## ASSESSMENT REPORT

### TOMINGLEY GOLD MINE Section 75W Modification MP 09\_0155 – Modification 2

Figure 4: Proposed Modification

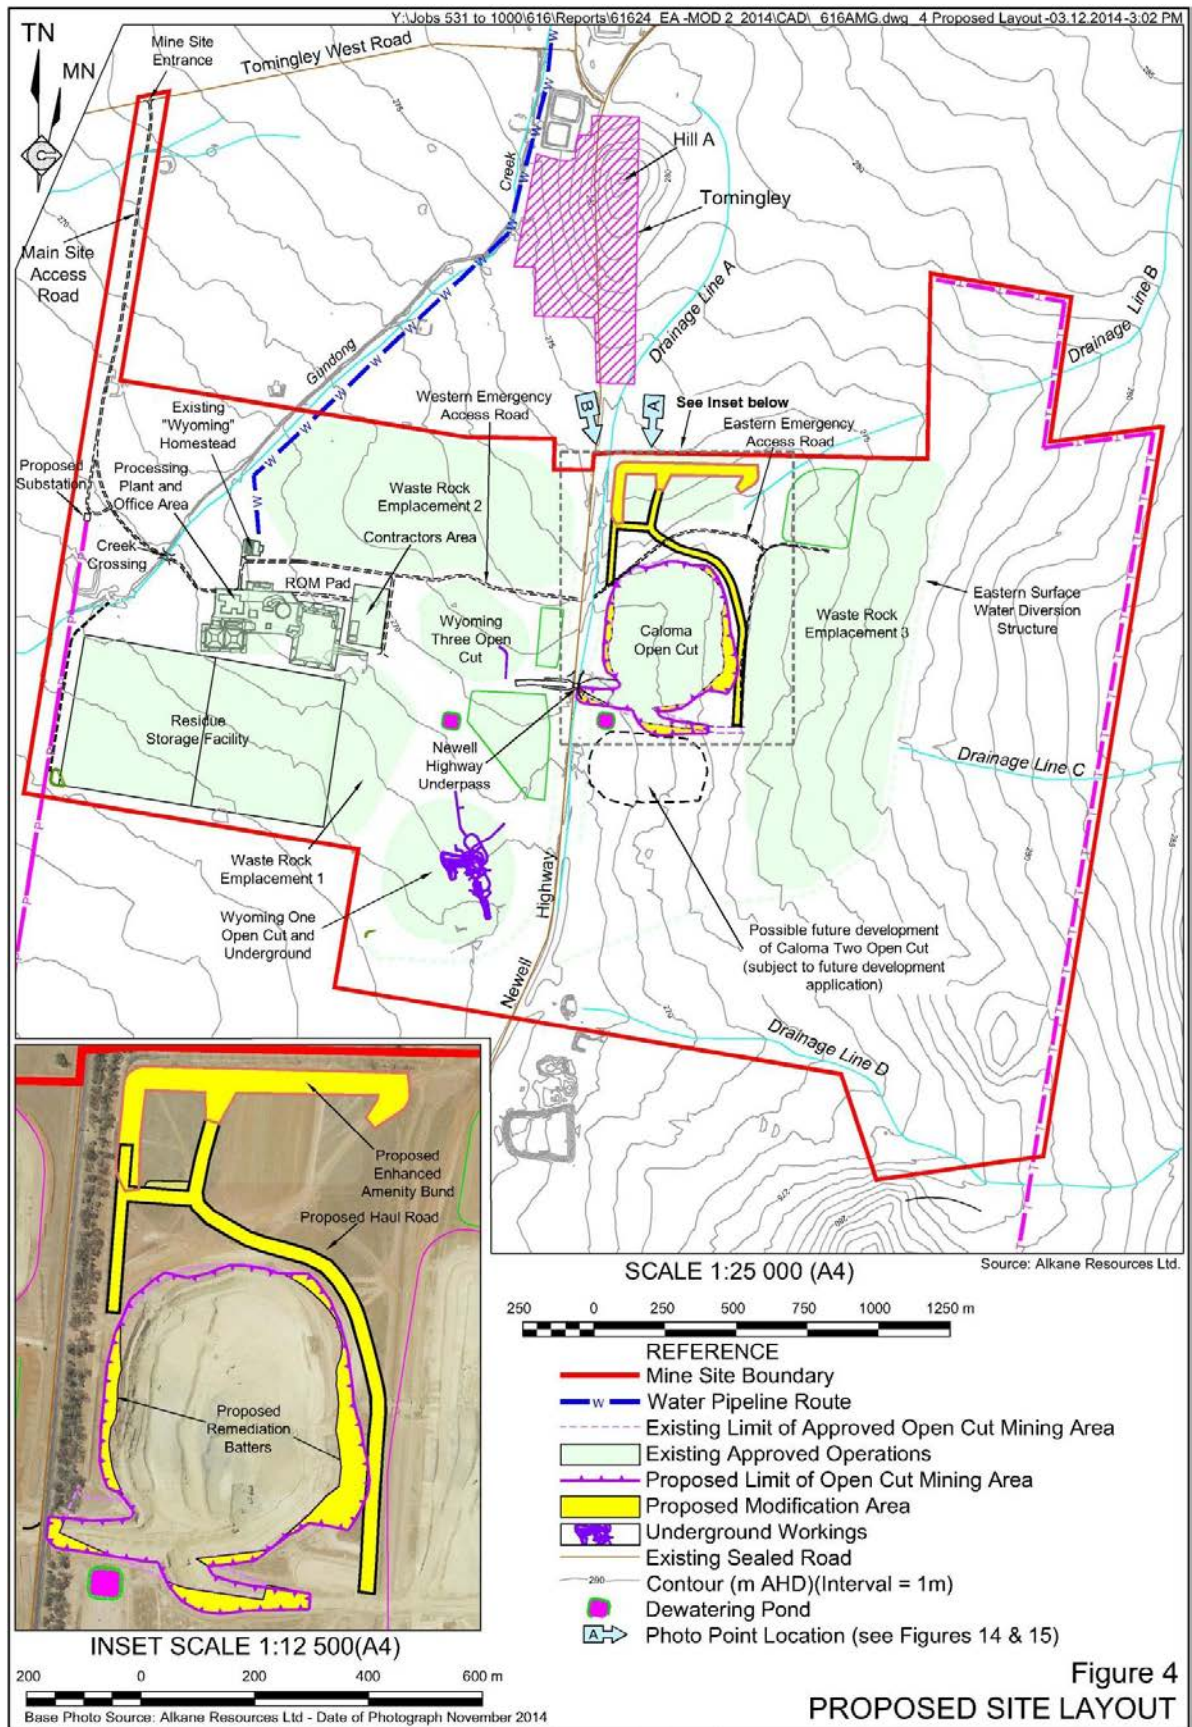
On 5 December 2014, Alkane submitted an application seeking to modify the project approval for the mine under Section 75W of the *Environmental Planning and Assessment Act 1979* (EP&A Act). The proposed modification involves (see Figure 4):

- a cut-back of the upper sections of the eastern and western walls of the Caloma open cut pit to ensure ongoing stability; and
- enhancement of the existing amenity bund to the north of the Caloma open cut pit to provide further noise attenuation for the residents of Tomingley village.

The proposed modification also involves construction of a haul road between the Caloma open cut pit and the modified amenity bund. Alkane anticipates the proposed cut-back and construction of the modified amenity bund would take between 1 and 4 months to complete.

Figure 5: Photomontage of Existing and Modified Views from Tomingley Village (southern)

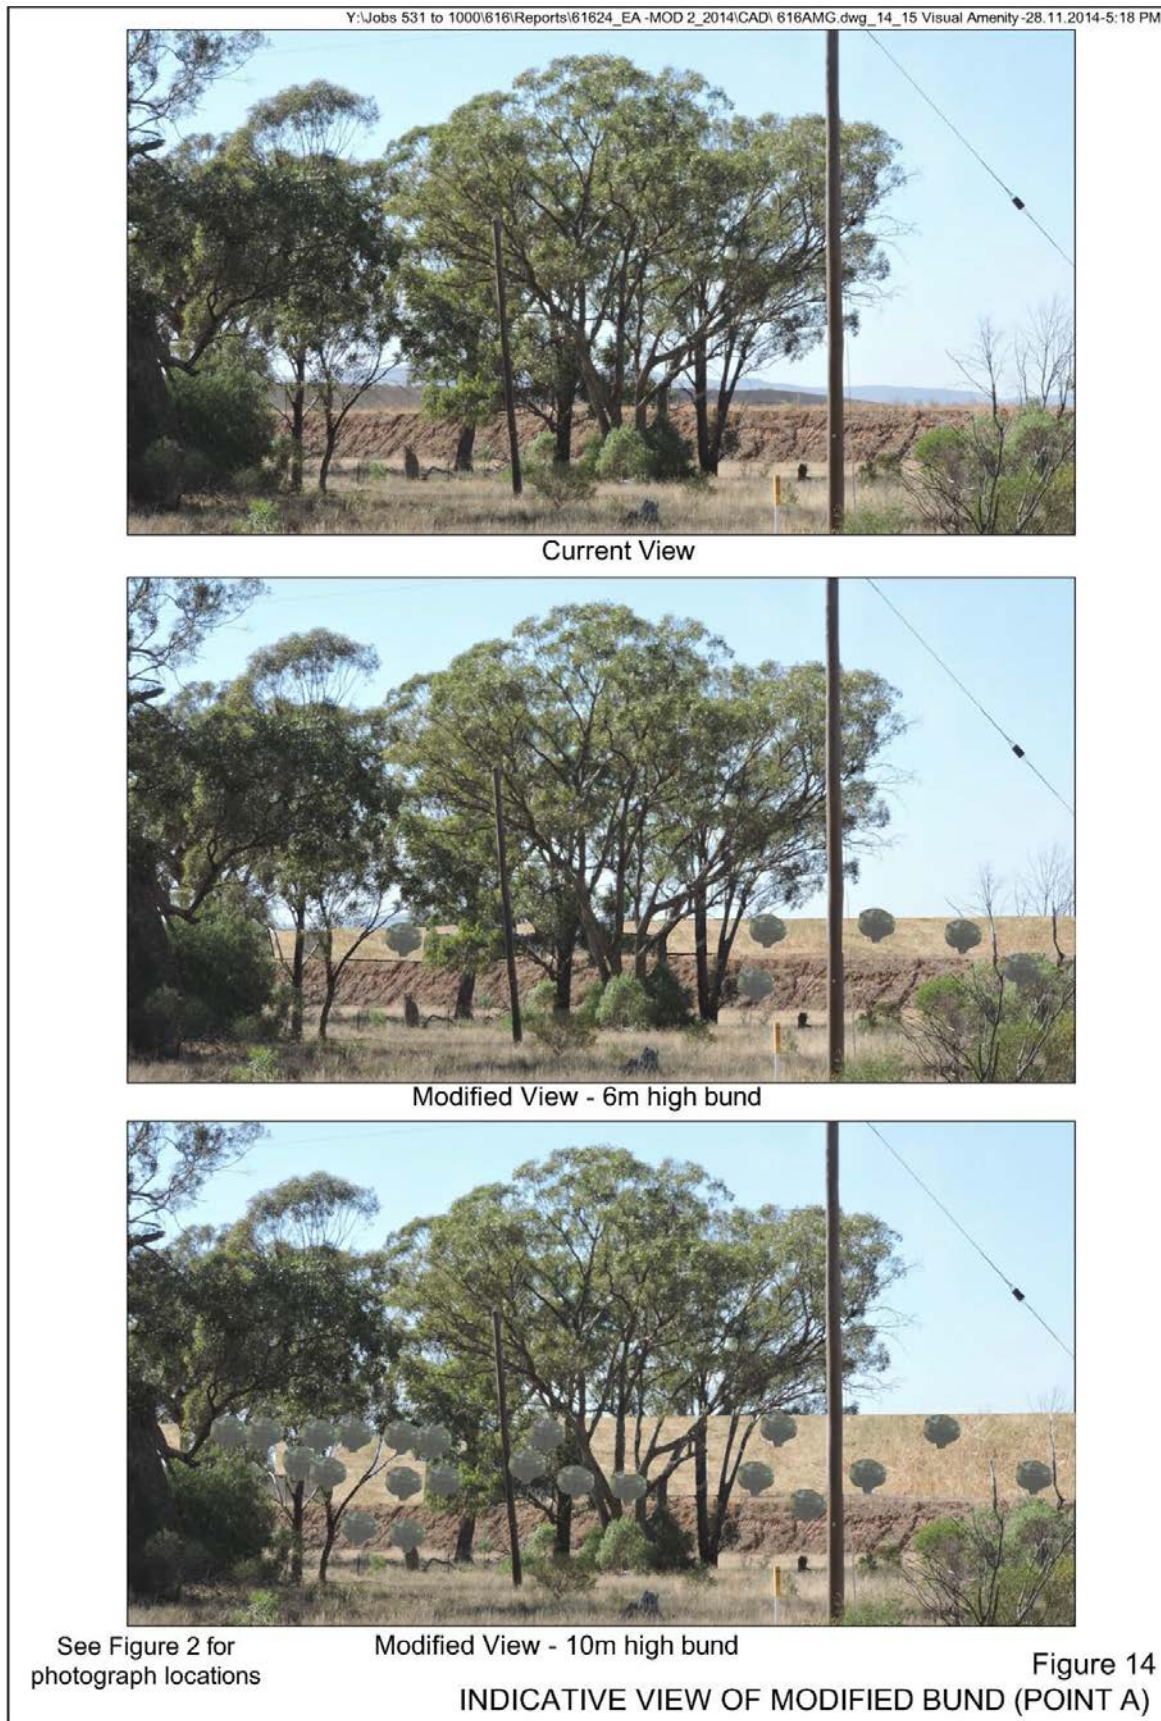
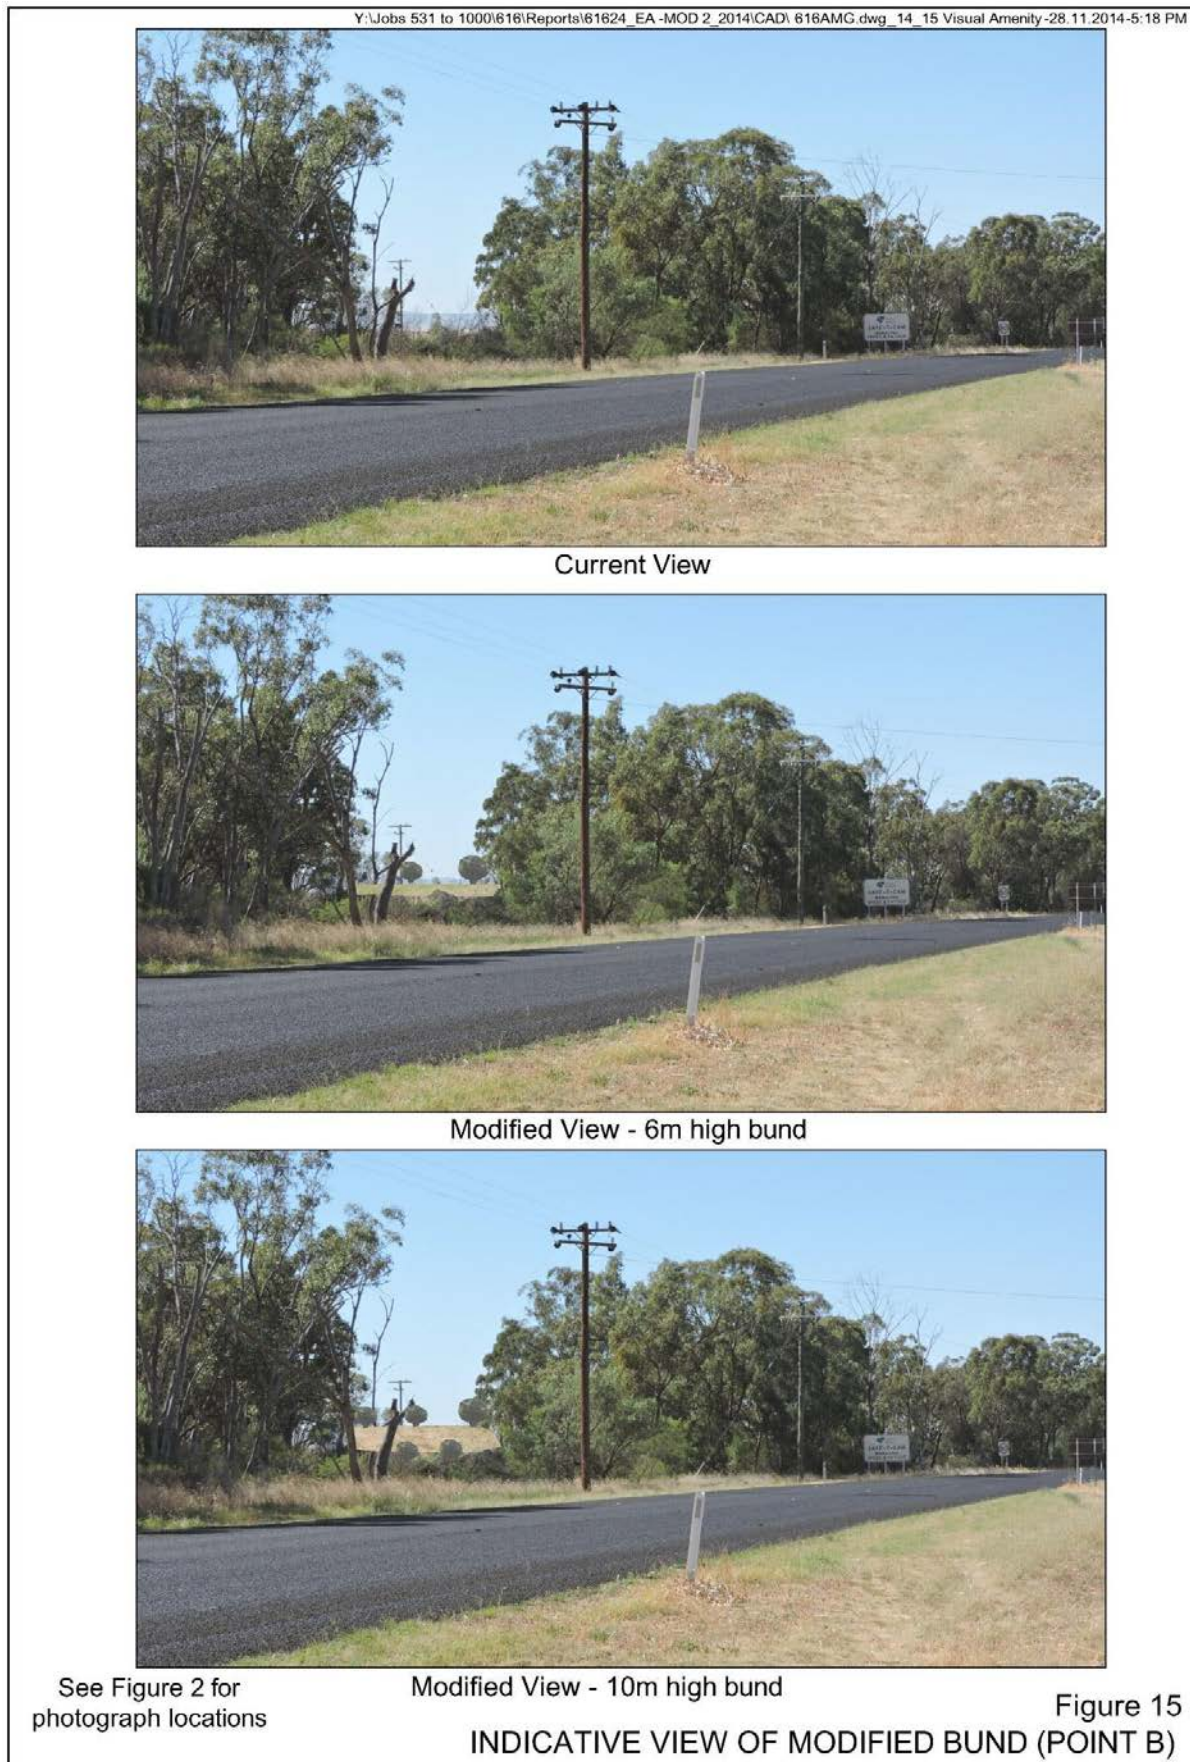
The EA included an assessment of the potential visual impacts to residents in Tomingley village and users of the Newell Highway assuming a modified amenity bund height of between 6 m and 10 m (refer Figures 5 and 6, respectively).

Whilst acknowledging that a modified bund height of up to 10 m would still remain well below the approved height of the waste rock emplacement 3 (i.e. 40 m), the Department considers that given the close proximity of the bund to residents in Tomingley village, the height of the bund should be restricted to a height of no more than 8 m. Alkane has agreed to this height restriction.
